ALERT SERVICE BULLETIN

205B-15-64

MODEL AFFECTED: 205B

SUBJECT: MAIN ROTOR BLADE BOLT 204-011-151-001
INSPECTION, REWORK AND REPLACEMENT OF

Figure 1. Main Rotor Blade Bolt Inspection and Rework

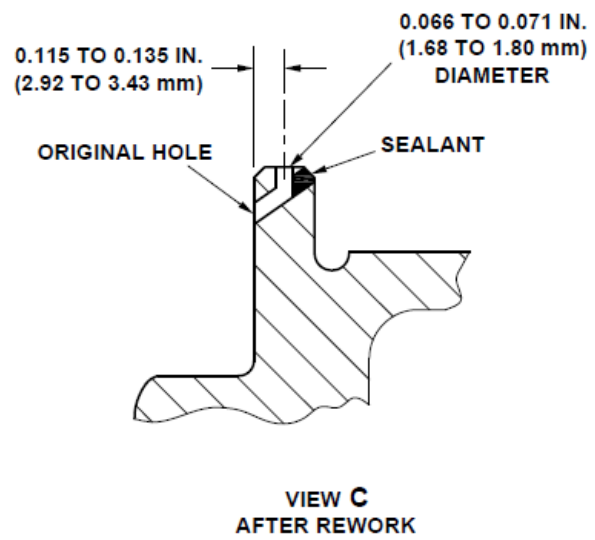
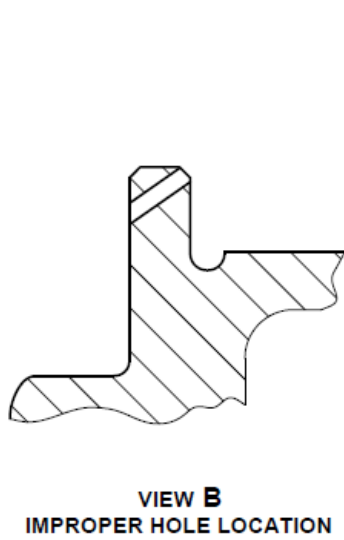
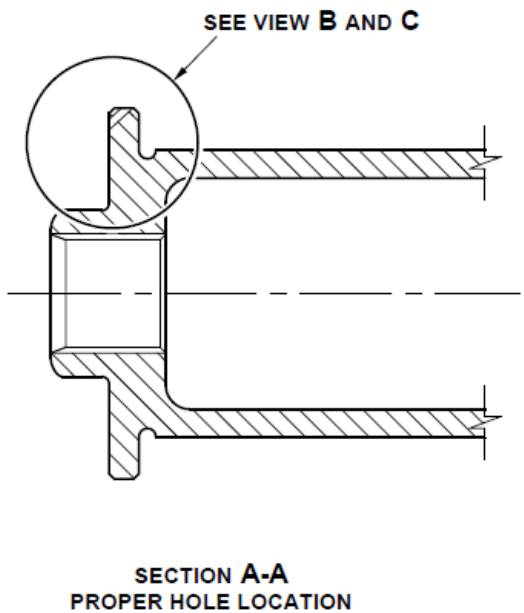
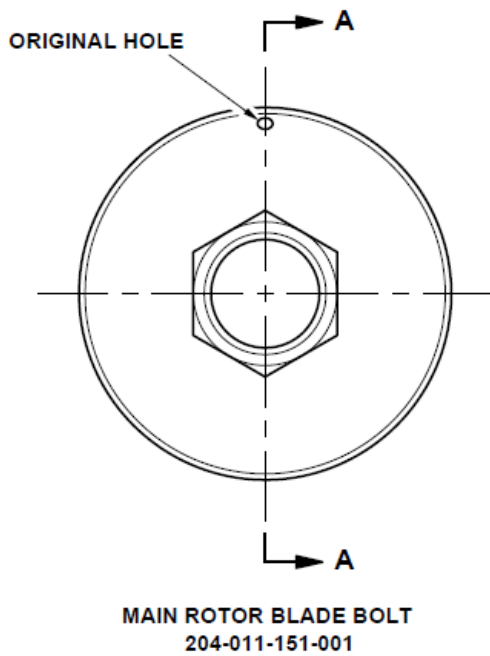
Main rotor blade bolts listed in Table 1 of the Accomplishment Instructions are suspected to have the lockwire hole for the lead weight plug incorrectly drilled. This non-conformity may prevent installation of the lockwire and lead to incorrect installation of the blade bolt. This bulletin mandates a one-time inspection for conformity of the affected blade bolts listed in Table 1 and provides rework instructions allowing the use of these blade bolts. After rework, affected blade bolts will require a repetitive 300 flight hours inspection of the reworked area. As a terminating action to this repetitive inspection, the reworked blade bolts will require replacement. As an alternative option to the rework, defective blade bolts that have not been installed and/or reworked can be returned to Bell Helicopter as "new part return" and a credit will be offered. Applicability of this bulletin to any spare part shall be determined prior to its installation on an affected helicopter.

1. Verify if any of the blade bolts listed in Table 1 are installed on a helicopter or in spare stock. If none of the blade bolts listed in Table 1 are found installed or in spares stock, go to step 3.
2. Blade bolts listed in Table 1 that have the safety wire hole drilled as shown in Figure 1, Section A-A, conform to the approved engineering. Go to step 3.
3. Make an entry in the helicopter logbook and historical service records indicating findings and compliance with this Alert Service Bulletin.
4. Blade bolts listed in Table 1 that have the safety wire hole drilled incorrectly as shown in Detail B, can either be returned to Bell Helicopter as “new part return”, or reworked as follows:

- a. Radially mark the location of the existing lockwire hole on the flange with a marker (Figure 1).
- b. Drill a 0.066 to 0.071 inch (1.68 to 1.80 mm) diameter hole in the center of the flange, as shown, to break into the existing safety wire hole.

- c. Break edges 0.0005 to 0.015 inch (0.013 to 0.38 mm) radius or 0.0005 to 0.015 inch (0.013 to 0.38 mm) x 40-50°.
- d. Verify the intersection of the two bolt holes with a 10X magnifying glass to ensure it is free of burrs or knife edges and that the opposing hole has no damage.
- e. Insert a piece of safety wire in the new hole that exits the upper surface of the flange and fill the lower end of the original safety wire hole with sealant (C-251). Make sure the sealant is flush with the end of the hole and the flange.
- f. Remove the piece of safety wire prior to sealant curing. Once the sealant has cured, fill and drain the new safety wire hole with primer (C-204).
- g. Reidentify the part number on the blade bolt assembly by adding the letter "R" after the last three digits using a permanent marker (i.e., 204-011-151-001R).
